INDESIT company

Model type:
WD125TSEX

Commercial code:
F027152

Technical Documentation guidelines

FIG. 1

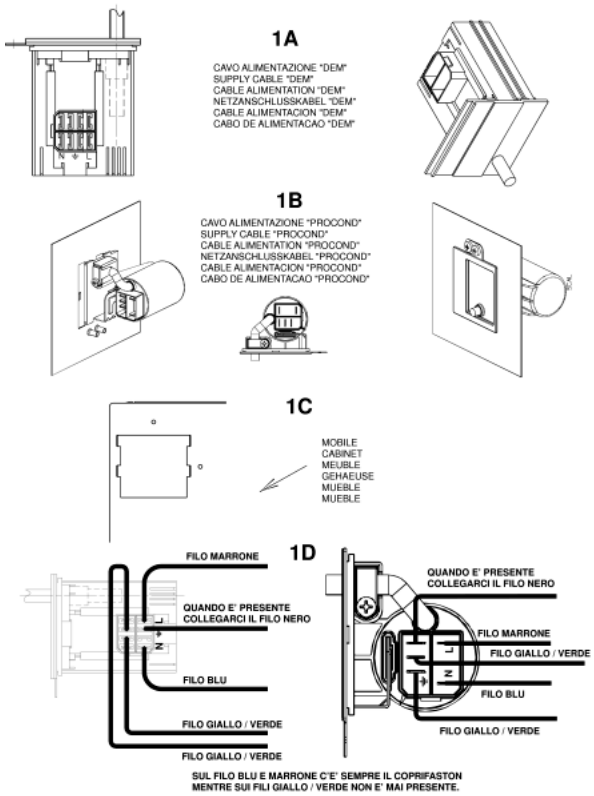
n1040276: Power supply cable + integrally moulded filter.

All appliances produced in the Comunanza (from serial no. 21008.0001), Teverola (from serial no. 21111.0001) and Brembate (from serial no. 21119.0001) factories have been equipped with power supply cables with integrally moulded filter (see fig.1 - 1A and 1B) and new units having a specific opening at the back for fixing the new cables (see fig. 1 - 1C).
The new units, together with the new cables, can be used in place of the premodification ones, by connecting the wiring to the cable, as shown in figure 1 - 1D.
The codes of the new units and of those replaced (ESI - table n1040276fig02), which will be managed until stocks run out, are given below.

IMPORTANT: the fixing / continuity screw is a specific self-scraping screw (code 092348) that ensures earth continuity between the filter and the unit. The same screw must be refitted in order to guarantee machine conformity.

The premodification wirings, are also managed for modified products by making the connection to the terminal block of the new cable as shown in fig. 1 - 1D.
The wiring diagrams given in the Documentation remain unchanged.

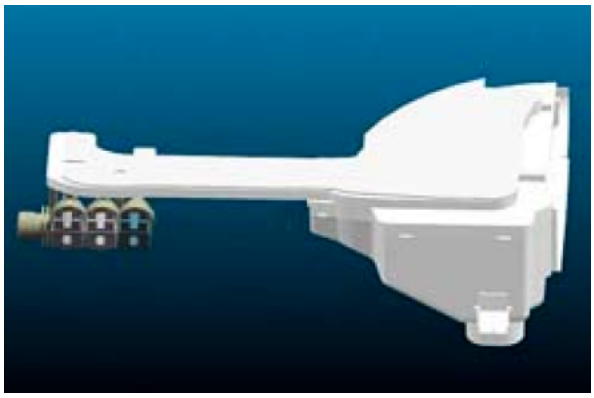
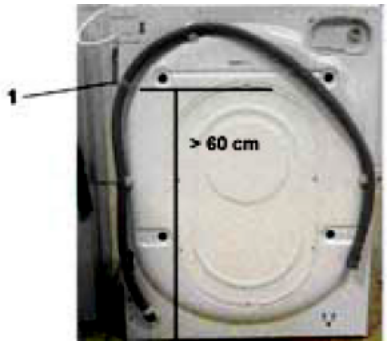
n1040282: New drainage OKO system.

From serial number 21219.0001, the new "OKO" drainage system has been introduced on the washing machines produced in the Comunanza factory.

- EEPROM (the OKO system requires a new setting of load timing parameters). THE NEW EEPROMS REPLACE ALL THE ONES CODED PREVIOUSLY.
- BOWL (hopper tube hole shifted forwards);
- DETERGENT LOADING TUBE (see fig. 1);
- PRESSURE SWITCH (changed levels);
- OKO PUMP BOWL BLOWER + BALL (see fig. 2A, 2B and 2C);
- CONDUCTIVITY SENSOR (if provided, it is shorter than the premodification item);
- DRAIN PUMP (without detergent collecting tube connection);
- HOPPER (shifted in front of detergent loading tube connection). Fig. 3A post-modification. Fig. 3B premodification);
- AIR TRAP (different shape);
- PRESSURE SWITCH TUBE (different length);
- DRAIN TUBE STOP (specific);

In particular, the OKO system consists of a spherical plastic component inserted in the tube that connects the bowl to the drain pump (see fig.2 A).
At the beginning of each wash cycle the washing machine fills water for 10 seconds and activates the drain pump for 2 seconds. In this way, the water level in the bowl is different from that in the drain tube; this difference increases the thrust of the ball upwards, closing the bowl-pump connection tube hermetically (see fig. 2D).
This system has the double advantage of:

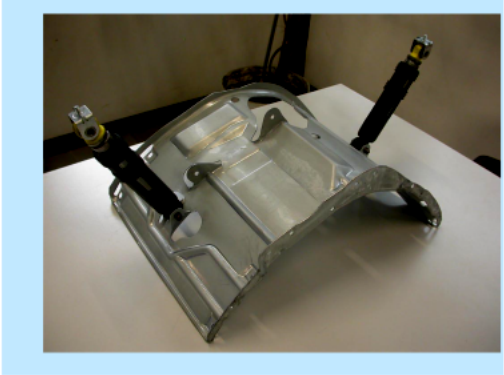
n1040325: New shock absorber fixing system with pin

From serial no. 40427.0001, shock absorbers have been fixed to the tank unit cradle with two 11 mm pins code C00110163 (see fig. 01 and 02 enclosed) in place of the 8 mm screws code 093750 and relevant locking nuts code 030443, on all washing machines and dryers produced in the Comunanza factory.
The items affected by this modification are:

To remove the shock absorber from the tank, first extract the pin with a few hammer taps (see fig.03) until it is aligned with the tank bracket and then pull it out with a pair of pliers (see fig. 04).
(To refit the shock absorber use a new pin. Insert the pin until the toroidal edge is aligned with the bracket.)
